Technical Service Bulletin: TSB170115

New Turbocharger Oil Drain Tube

Figure 1: Existing Turbocharger Oil Drain Tube, Part Number 3975076.

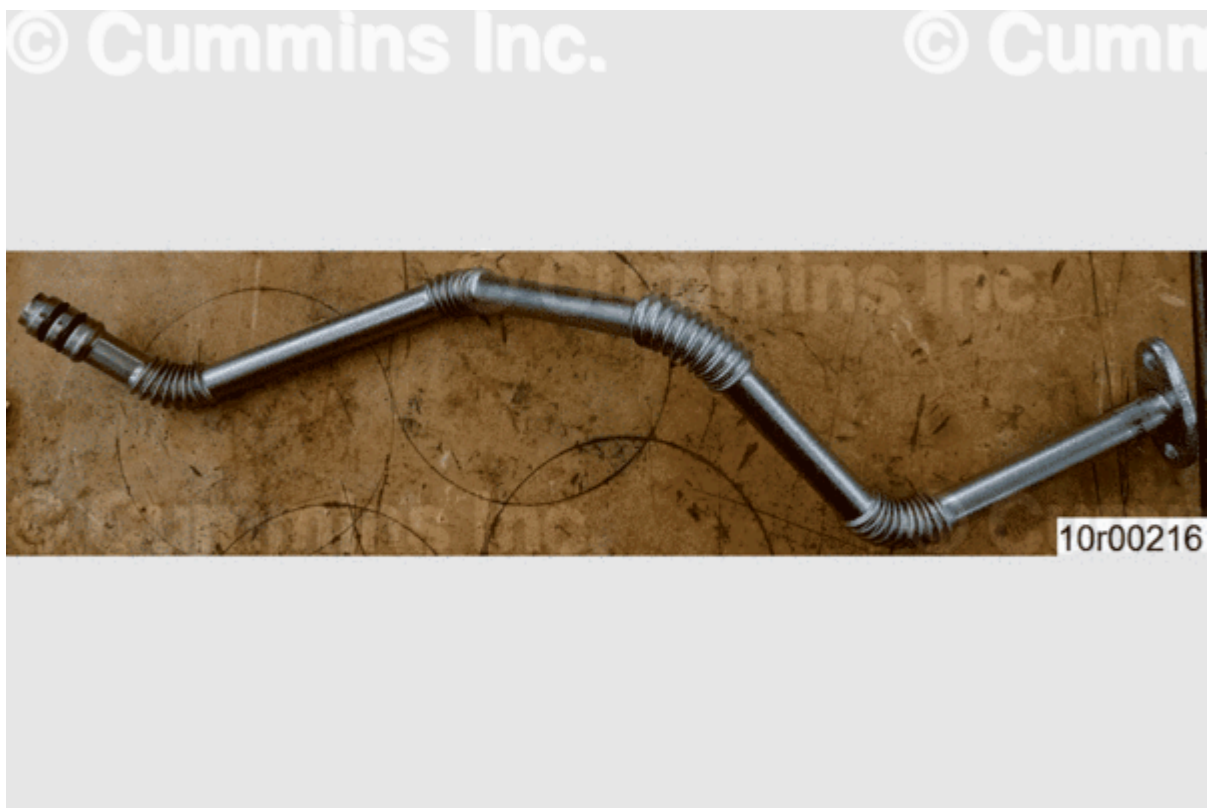
Path of turbocharger oil drain tube was changed to correct interference issues.

A new turbocharger oil drain tube part number is available.

Figure 2: New Turbocharger Oil Drain Tube, Part Number 5368665.
